Subject: License Amendment for MIT Research Reactor, License No. R-37, Docket No. 50-20,
Technical Specification No. 6.6 - "Design and Operation of the Fission Converter
Facility"

Safety Review #-0-01-8 - Changes to MITR Technical Specification 6.6.3

To: QA File M-97-3
From: G. Kohse
Date: February 16, 2001
Subject: pH and Conductivity Measurement in the FCB D₂O System

Model 709 Level Switch Float and Body Top-Mounted, One Switch Station

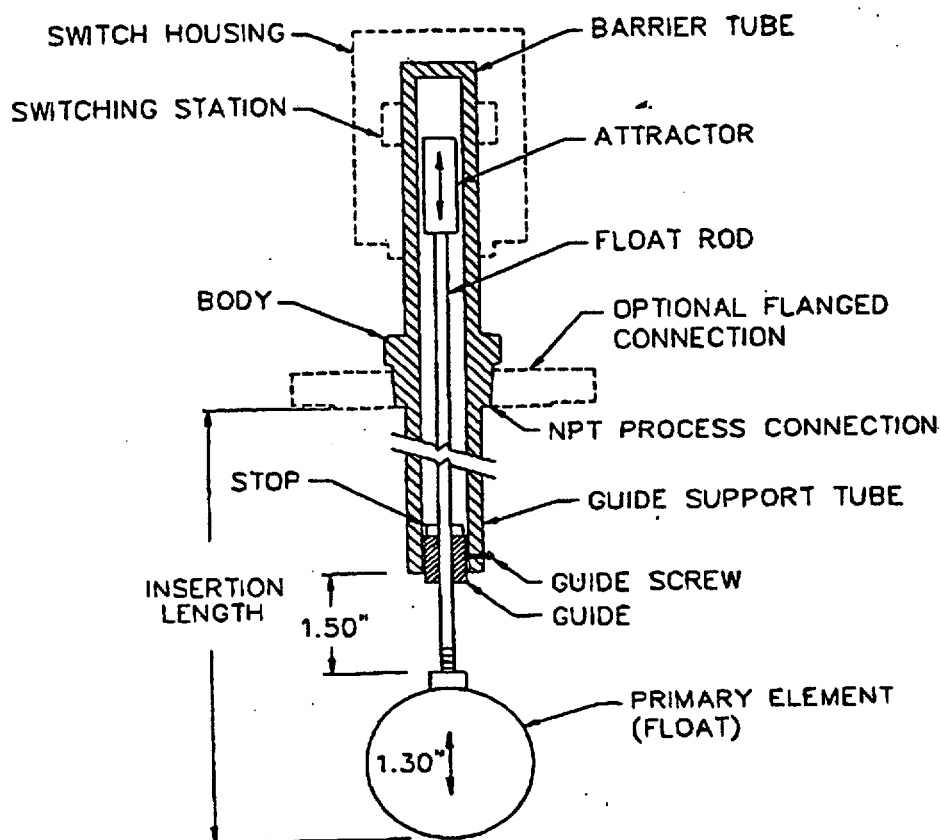
Specification 2(d) The Fission Converter (FC) tank coolant level channel provides a reactor scram and CCS closure if the FC coolant drops below 2.1 m above the top of the fuel. The level probe (a float switch, vendor's diagram attached) is set to activate at 2.2 m above the top of the fuel. This position is not adjustable. Any significant positioning changes would occur only if the switch were to become detached from its position. If this were the case, the level probe functional test as required in TS 6.6.3.1 would indicate the malfunction.

A calibration, as required in TS 6.6.3.2, is very difficult in that the FC top shielding and lid cover must be removed, D₂O slowly removed from the FC tank, and the level measured. This requires significant manpower and personnel dose to measure an activation level which cannot change. It is therefore proposed to eliminate TS 6.6.3.2(d). It should be noted that TS 6.6.3.1 remains unchanged and it requires, among other things, an operability check of the FC tank coolant level channel. Hence, the proposed elimination of TS 6.6.3.2(d) does not decrease safety. Operability of the level channel is still assured via testing. The only change is to eliminate a calibration requirement that is both difficult to perform and wasteful of D₂O, and which provides no benefit because the probe's position isn't subject to gradual change. The only possible failures in design are abrupt and those are detected by the functional test.

- a. Neutron flux level channel,
 - b. Primary coolant flow channel, *and*
 - c. Primary coolant outlet temperature channel, *and*
 - ~~d. Fission converter tank coolant level channel.~~

Calculated pH - Conductivity Relationship for Water + "Typical" Acid or Base

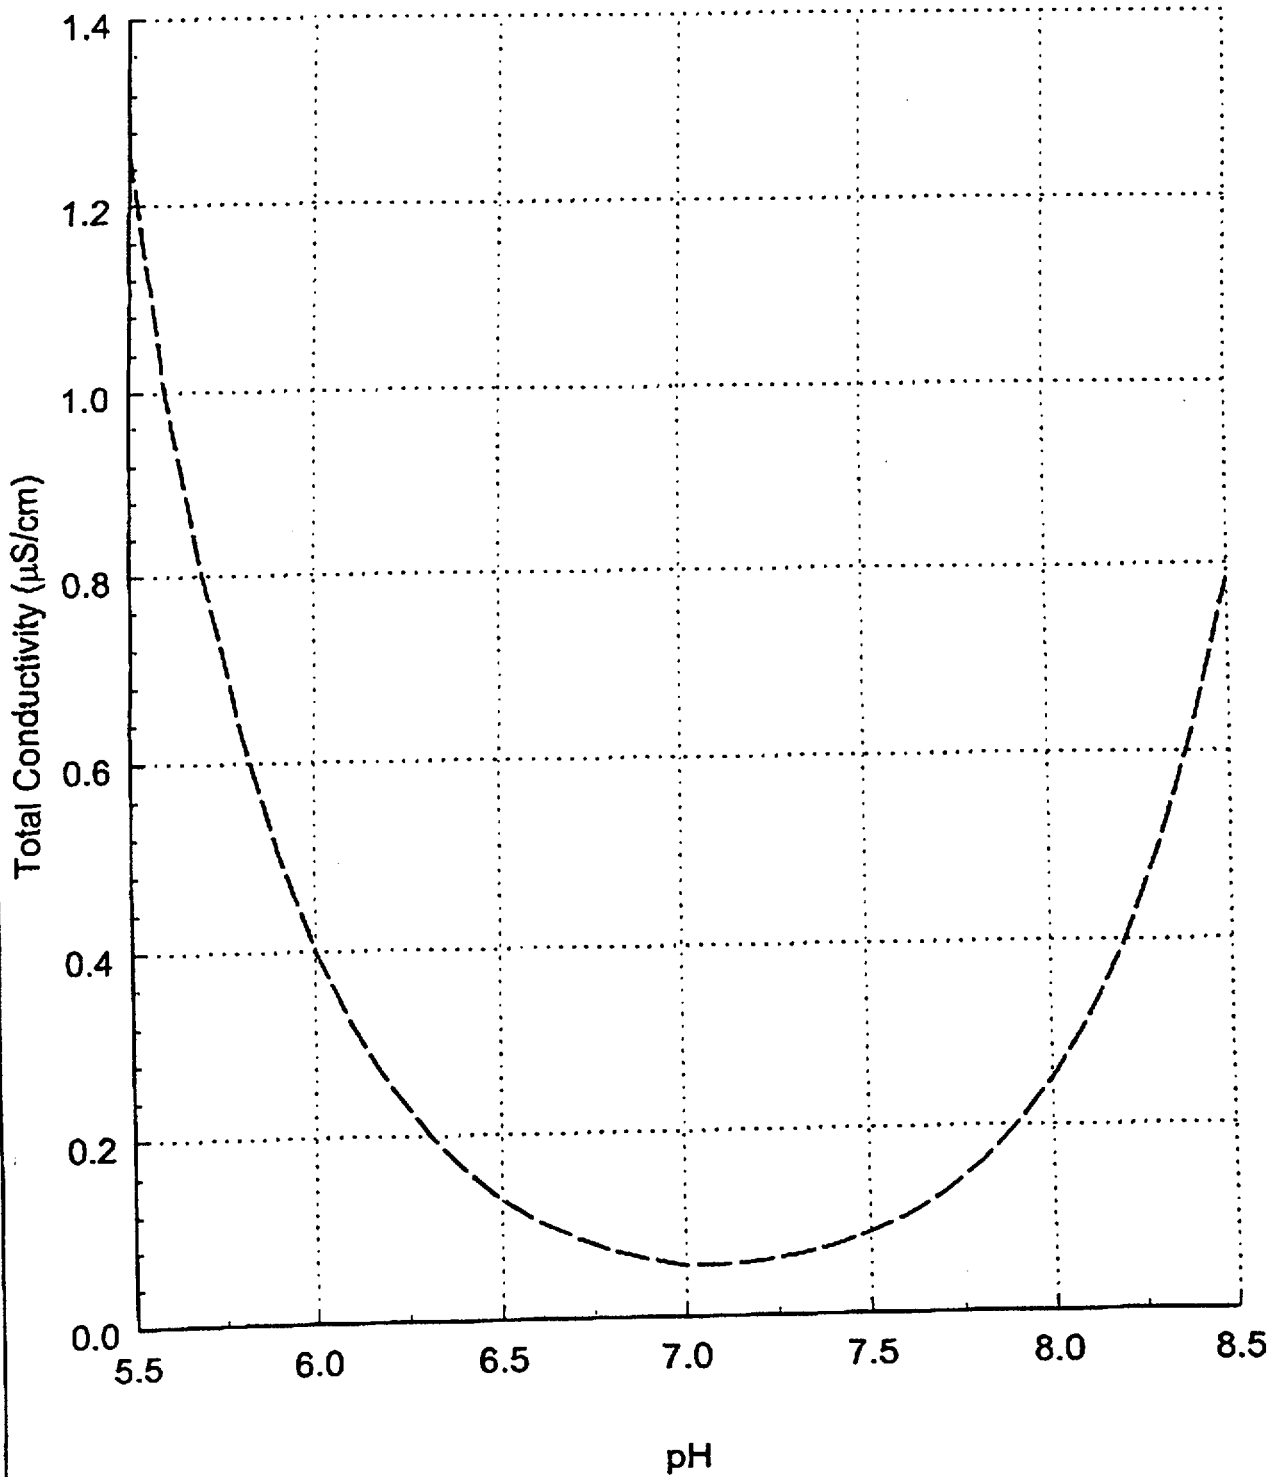
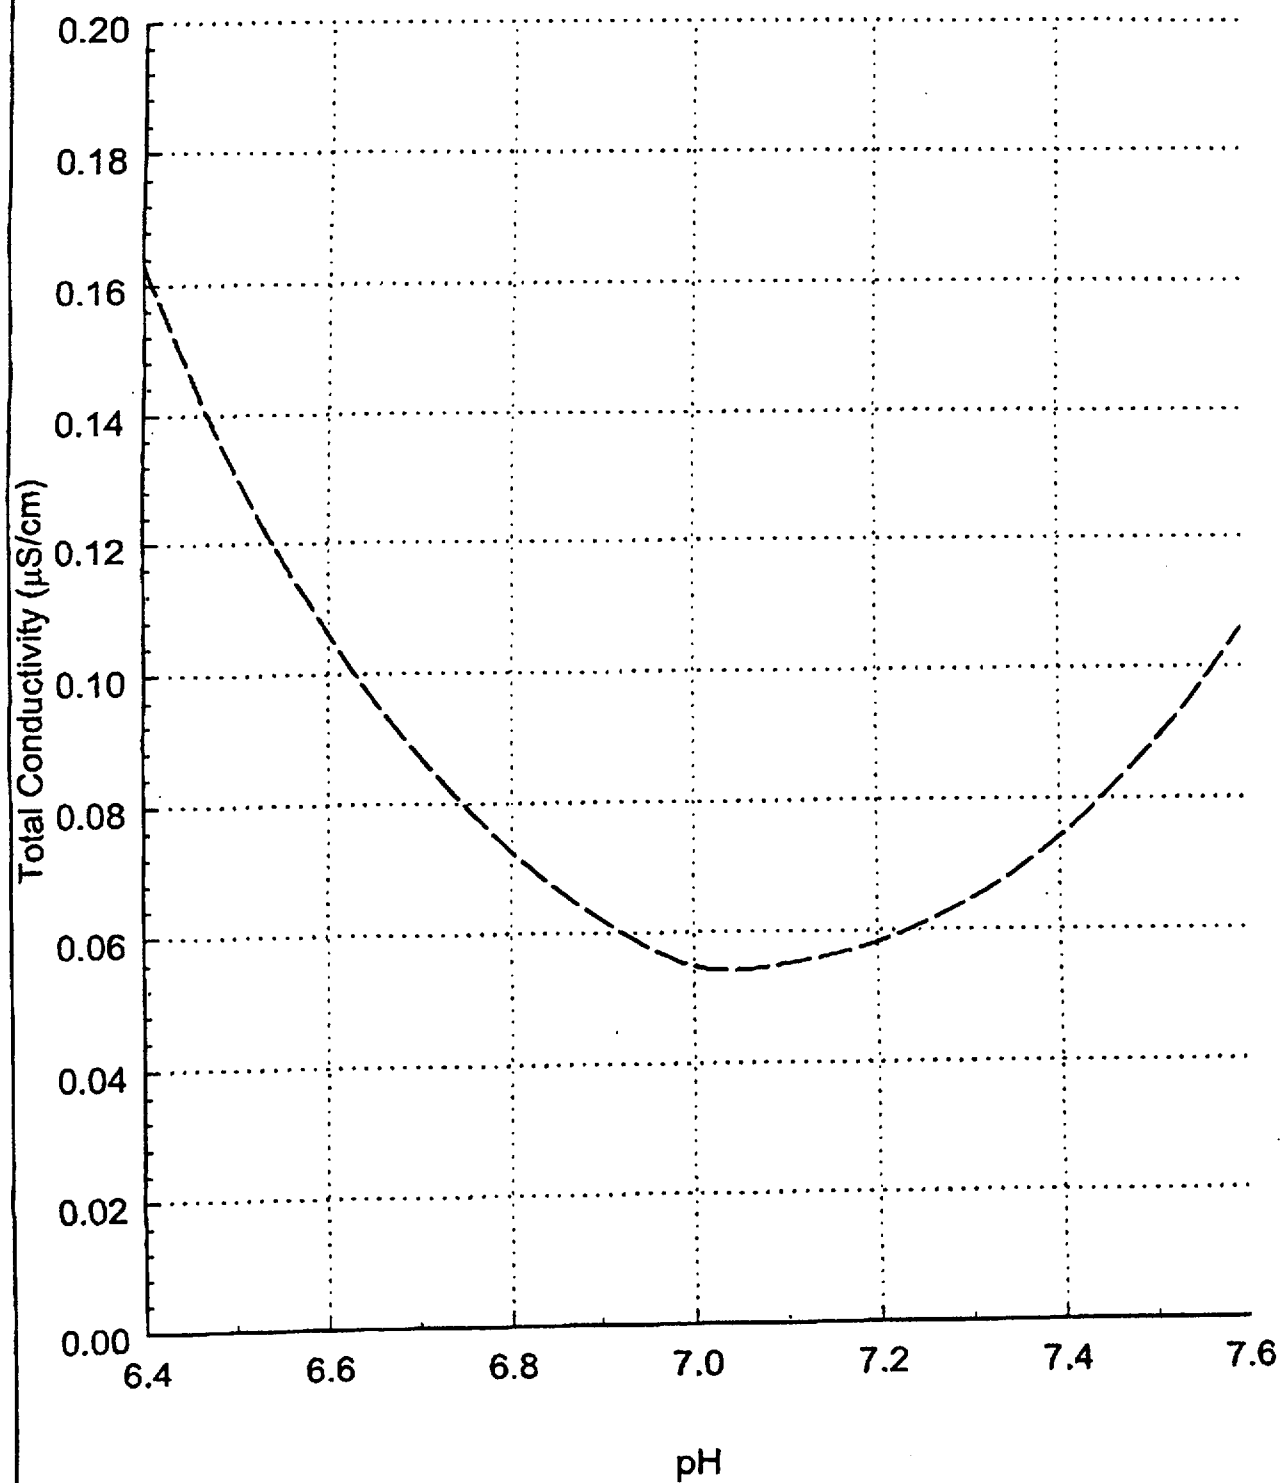
Specification 4 Since the FC coolant is high purity D₂O, and is continually circulated through a cleanup loop, the ionic strength of the D₂O is very weak, making pH measurements difficult. In addition, pH measurements result in above 10 ml of D₂O being wasted each month. A low conductivity would also mean that the pH must be near 7.0 (see attached memo from G. Kohse). Typical FC conductivity readings are about 0.06 μ S/cm. These readings are taken prior to FC operation, with the temperature never exceeding 35 °C. It is proposed to change the wording of T.S. 6.6.3 as follows:

The attached figures plot the conductivity - pH relationship obtained by this procedure, first for the pH range 5.5 - 8.5 and then an expansion of the region from pH 6.4-7.6. To use the figures to establish a probable pH range for any given conductivity, simply draw a horizontal line at the conductivity value and note the x-intercepts of this line on the curve. If ionic species are present which do not affect the pH, the actual pH range would be represented by a lower conductivity value and hence would be closer to neutral. For example, if the conductivity is measured to be $0.06 \mu S/cm$, the pH must lie between about 6.9 and 7.2. It is therefore unnecessary to do a batch pH measurement to confirm that pH is within the allowable limits, particularly if no change in conductivity has been observed since the most recent pH measurement.

4. The gross β - γ activity of the fission converter primary coolant shall be determined at least monthly. The conductivity of the fission converter primary coolant shall be determined either by a continuous on-line instrument or a monthly sample.

The pH of the fission converter primary coolant shall be measured monthly if the average conductivity exceeds 0.10 μ S/cm. The tritium content of the coolant shall be determined quarterly if D₂O is used as the fission converter primary coolant.
